SUBMITTAL TO THE BOARD OF SUPERVISORS
COUNTY OF RIVERSIDE, STATE OF CALIFORNIA

SUBJECT: FACILITIES MANAGEMENT (FM) AND RIVERSIDE COUNTY FLOOD CONTROL AND WATER CONSERVATION DISTRICT (DISTRICT): Flood Control and Water Conservation District Office Tenant Improvement Project – Approval of Construction Contract with PCN3, Inc., District 1. [$8,389,300 – 100% District Special Accounting Fund 15000 (Previously Approved Project Budget)]

1. Approve Addenda No. 1 through No. 4 to the plans and specifications for the Flood Control and Water Conservation District Office Tenant Improvement Project issued prior to the bid opening date of April 30, 2026;

SHEET NUMBER:
M-3.5

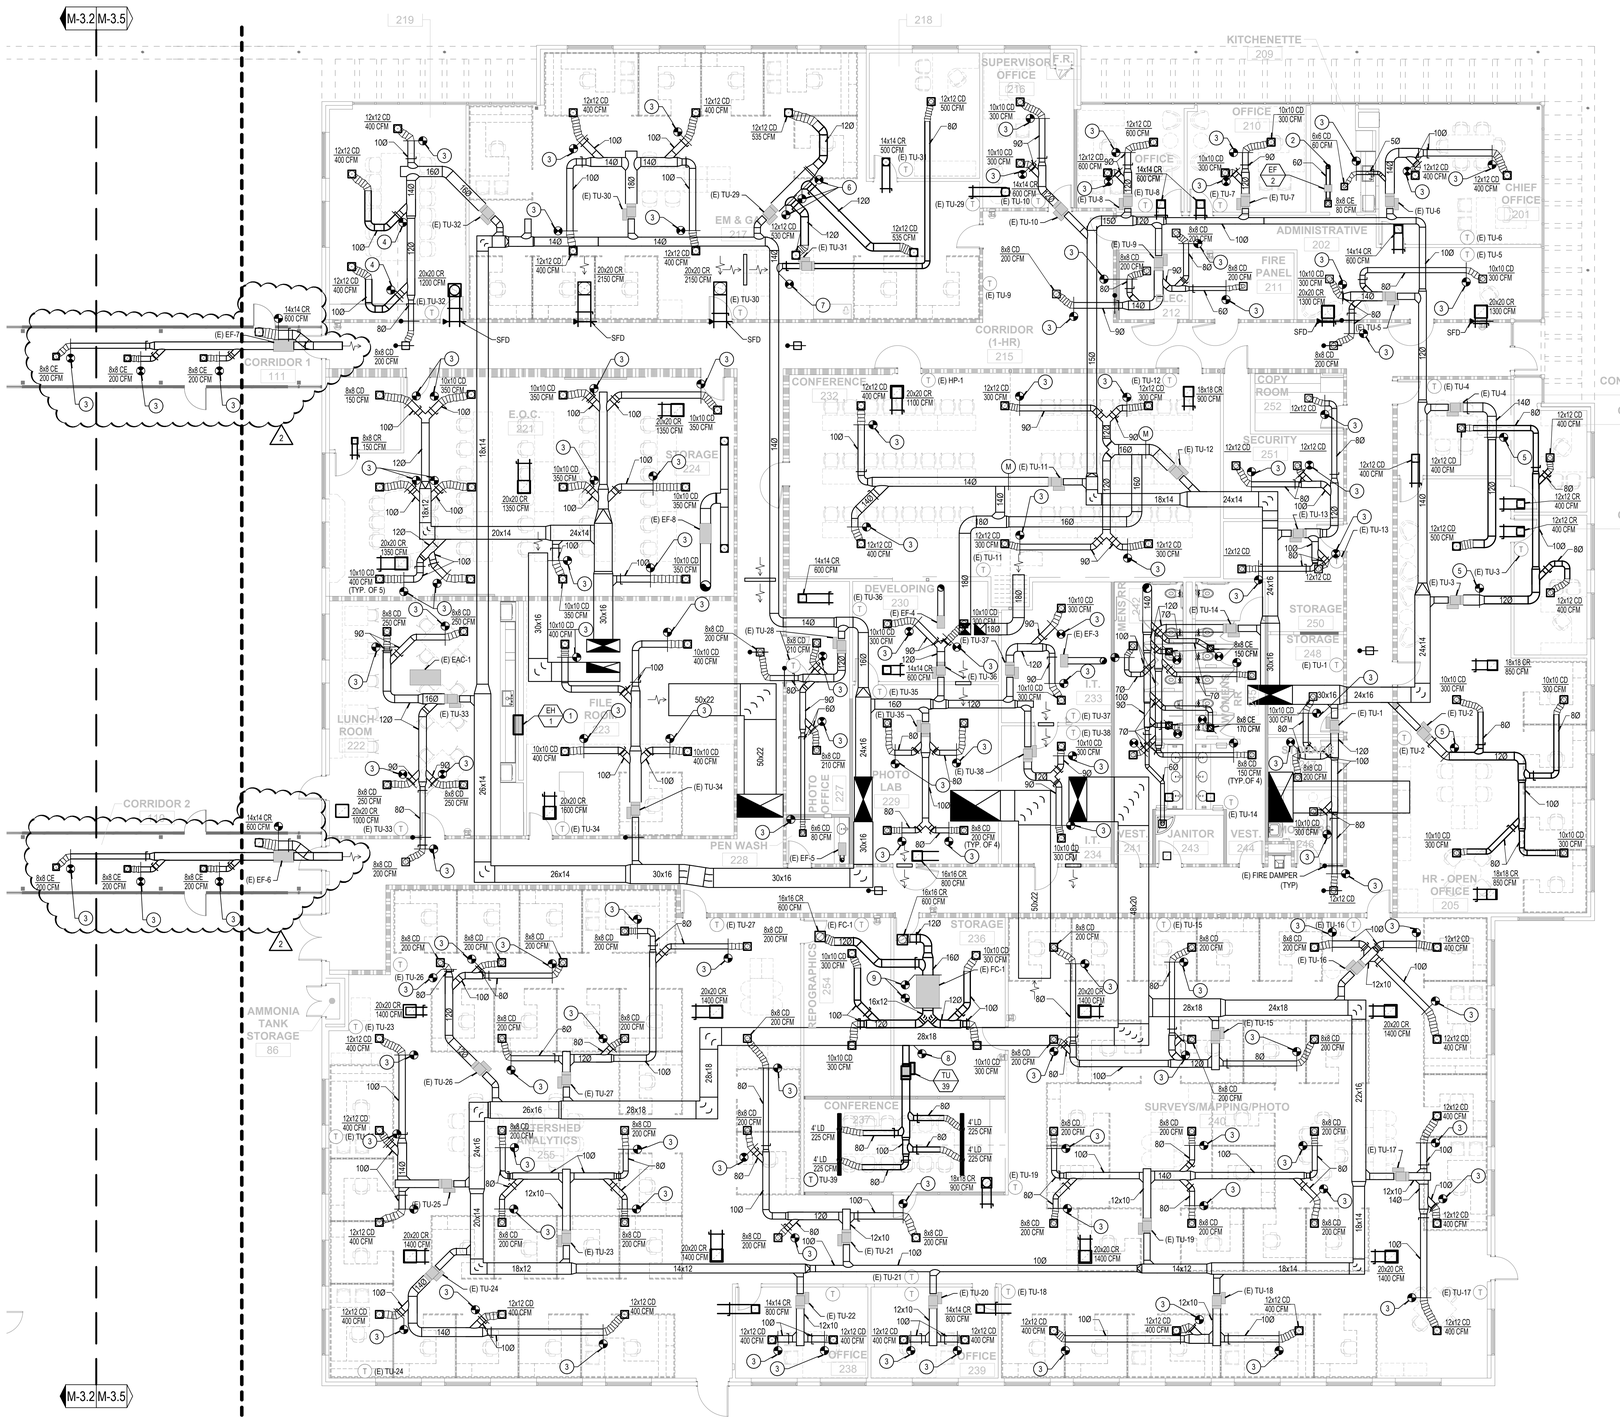
- M-2.2: MECHANICAL DEMOLITION PLAN – BUILDING 1
  a. Revised plan to show replacement of ceiling diffusers in connecting corridors.
- M-3.5: MECHANICAL REMODEL PLAN – BUILDING 1
  a. Revised plan to show replacement of ceiling diffusers in connecting corridors.

BUILDING 1A RESTROOM WASTE & VENT PLAN

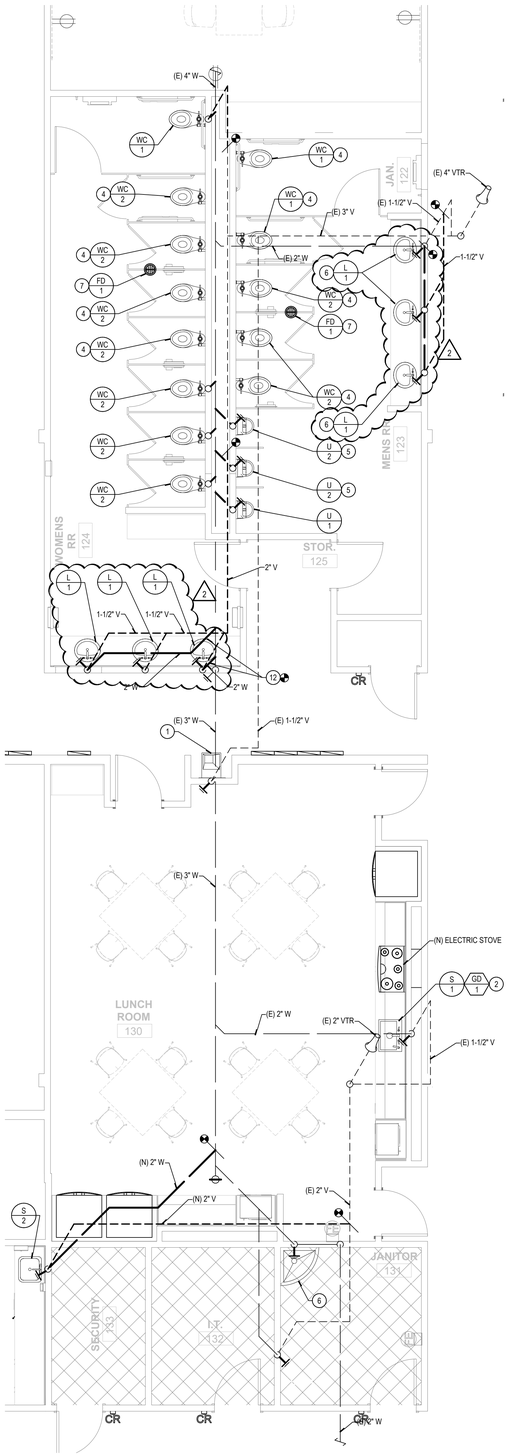
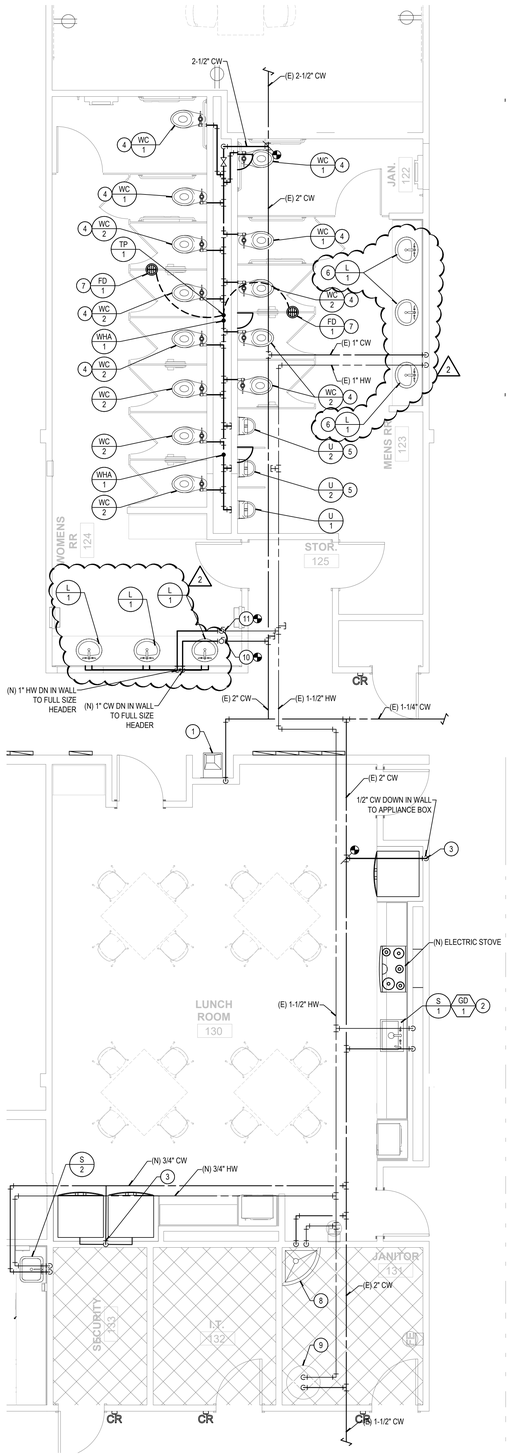
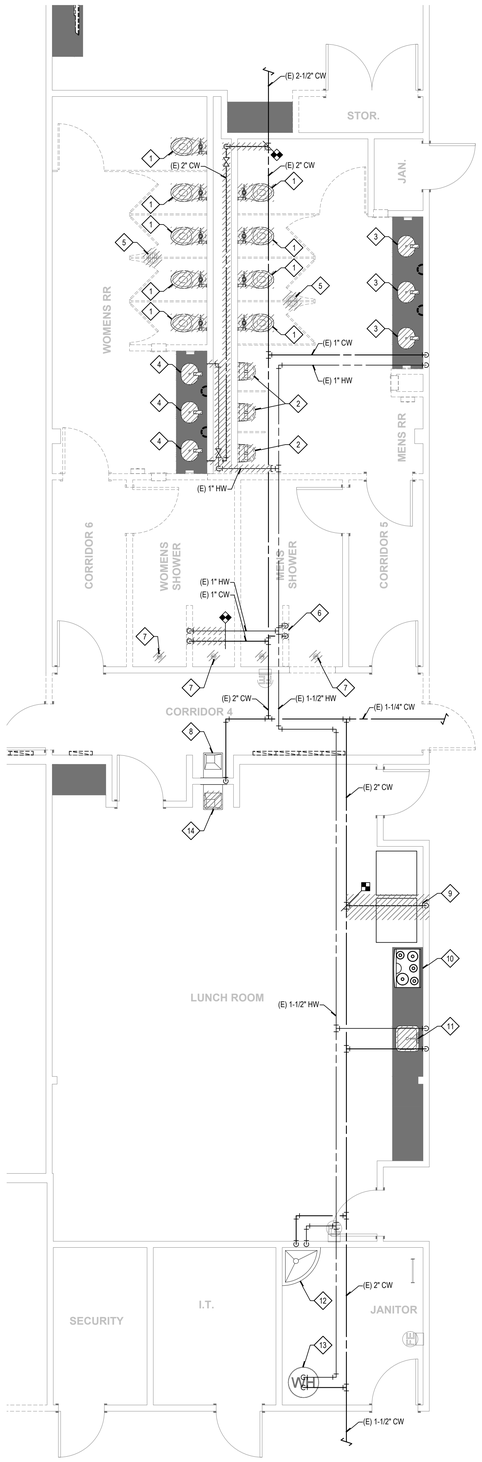
- P-0.1: PLUMBING LEGENDS NOTES & SCHEDULES
  a. Revised Fixture Schedule (L-1) selection.
- P-4.1: PLUMBING ENLARGED PLANS – BUILDING 1A
  a. Highlighted fixtures that have been updated in the Fixture Schedule.
- P-4.2: PLUMBING ENLARGED PLAN – BUILDING 1
  a. Highlighted fixtures that have been updated in the Fixture Schedule.

SHEET NUMBER:
E-2.2

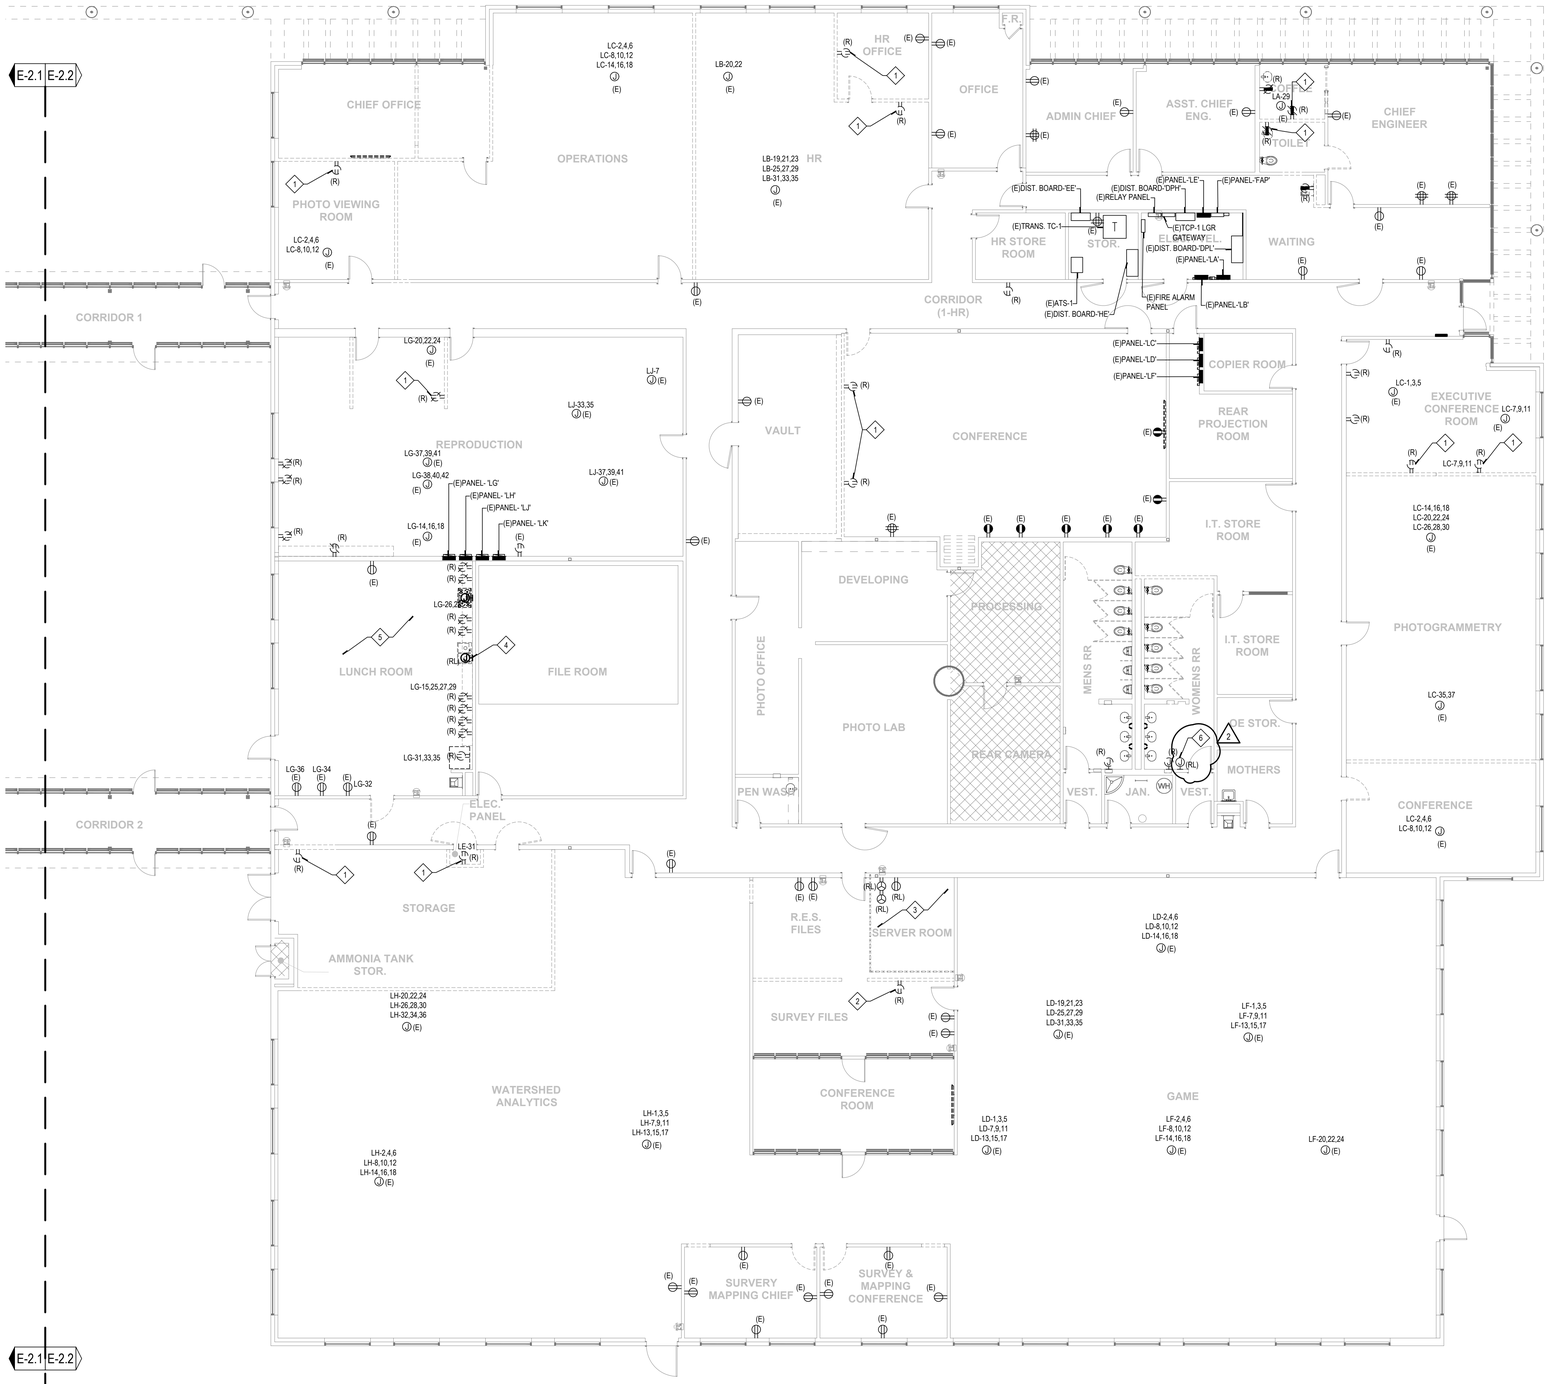
b. Added photocell for control of F15C linear light fixture at skylight in File Room 223
- E-2.2: ELECTRICAL DEMOLITION PLAN - BUILDING 1
  a. Update to the Women's Restroom. One Door push button was relocated per architectural drawings

SHEET NUMBER:
E-4.2

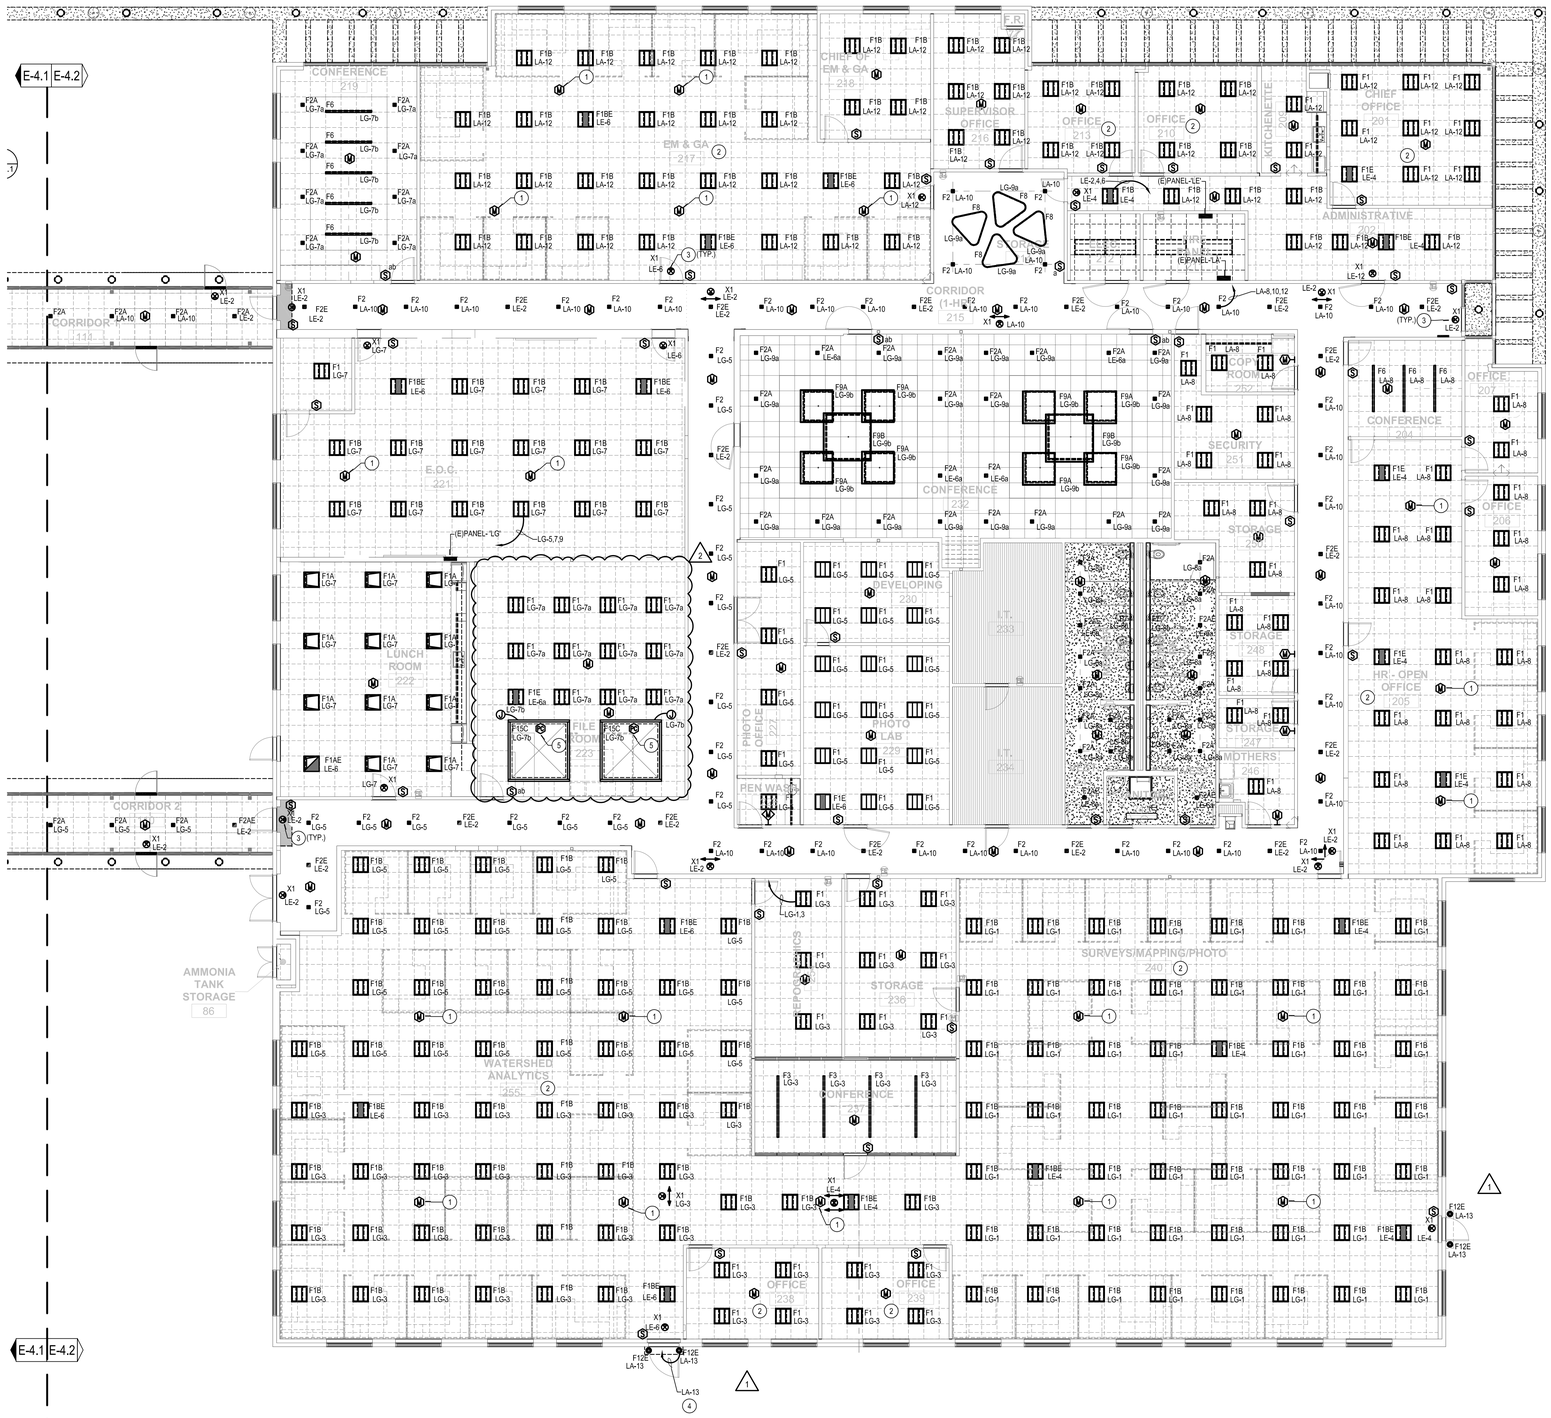
c. Added photocell for control of F15C linear light fixture at skylight in Lunch Room 130
- E-4.2: ELECTRICAL REMODEL LIGHTING PLAN – BUILDING 1
  a. Added F15C linear light fixture at skylight in File Room 223

SHEET NUMBER:
E-5.1

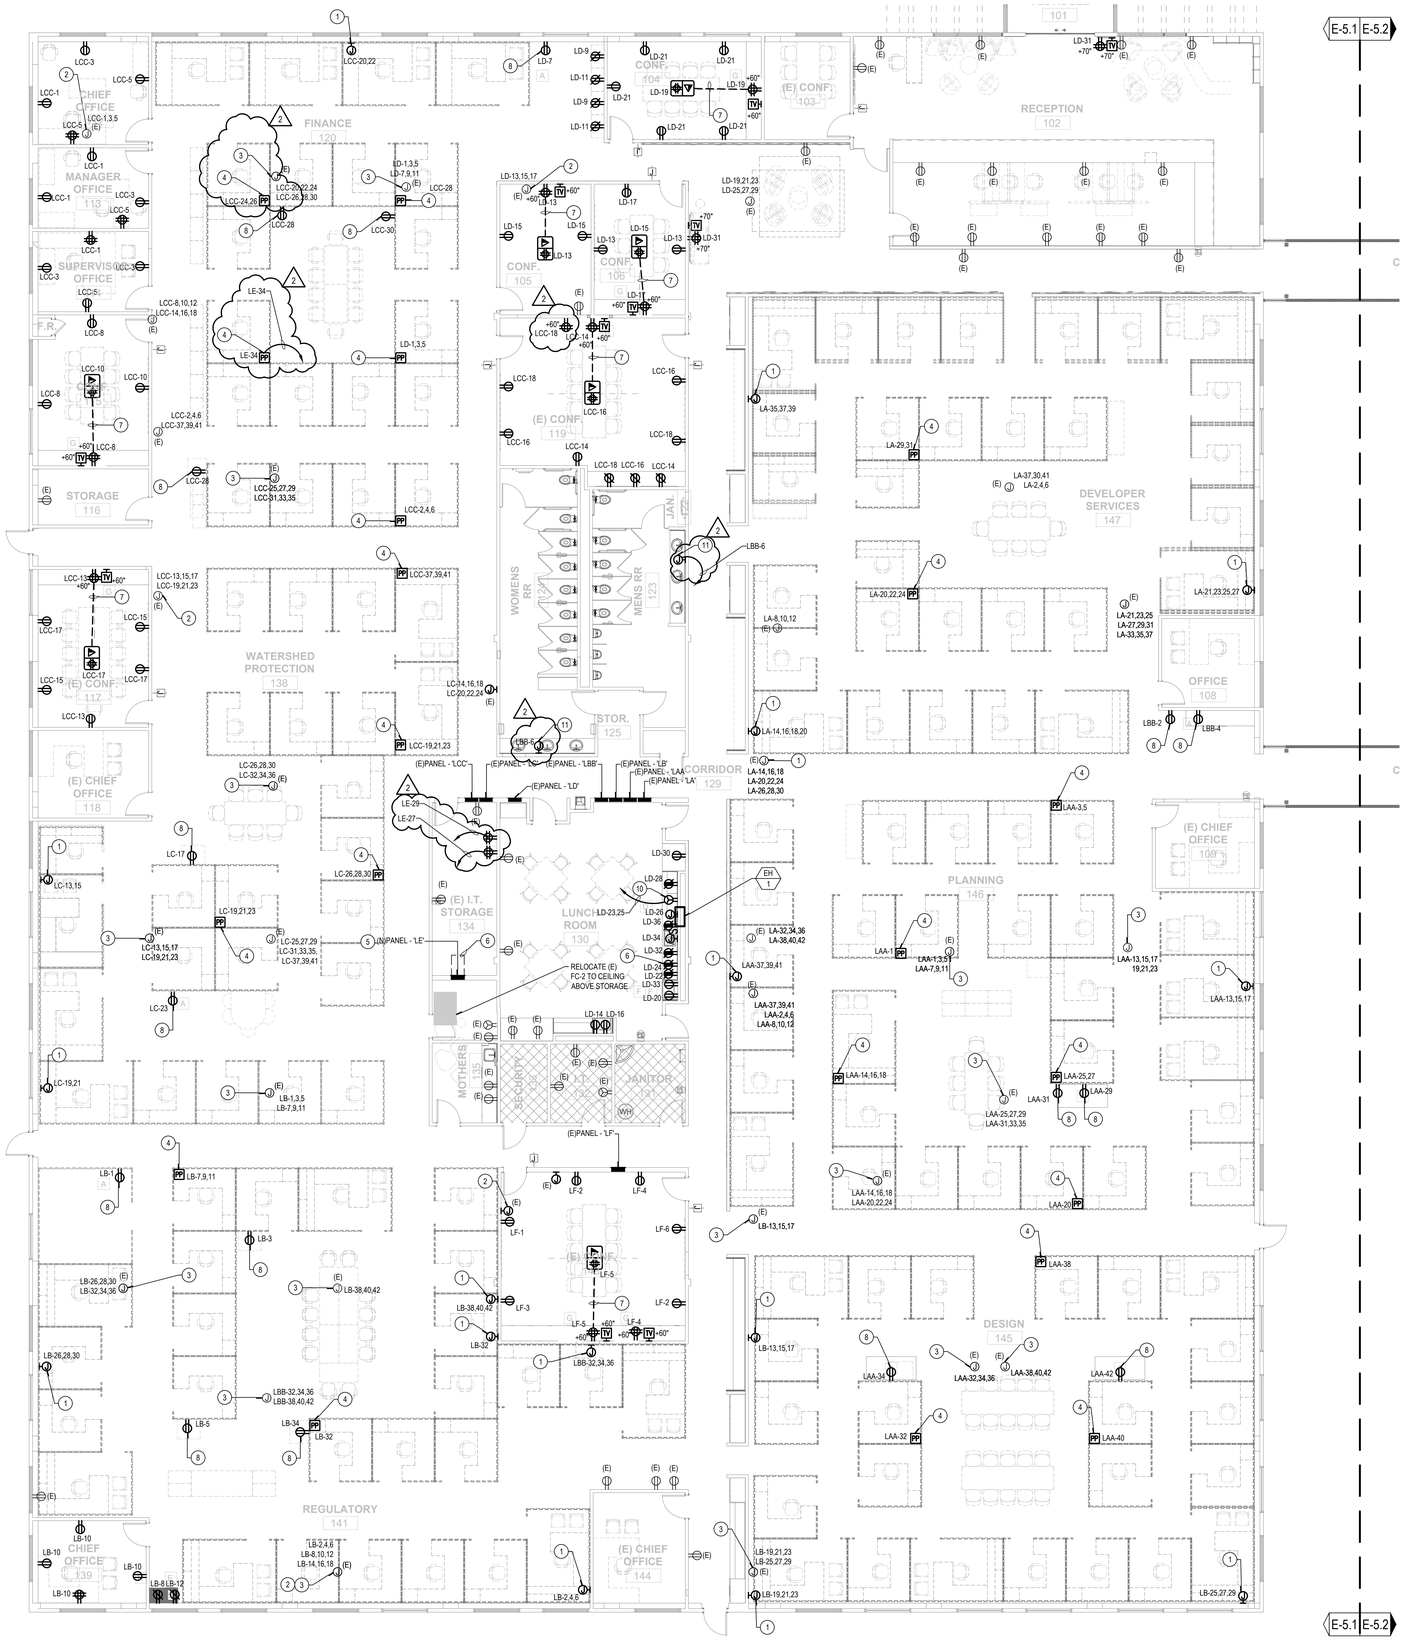
d. Added power receptacles for LV equipment in IT 233 & Security 251
- E- E-5.1: ELECTRICAL REMODEL PLAN - BUILDING 1A
  a. Revised power pole location Finance 120
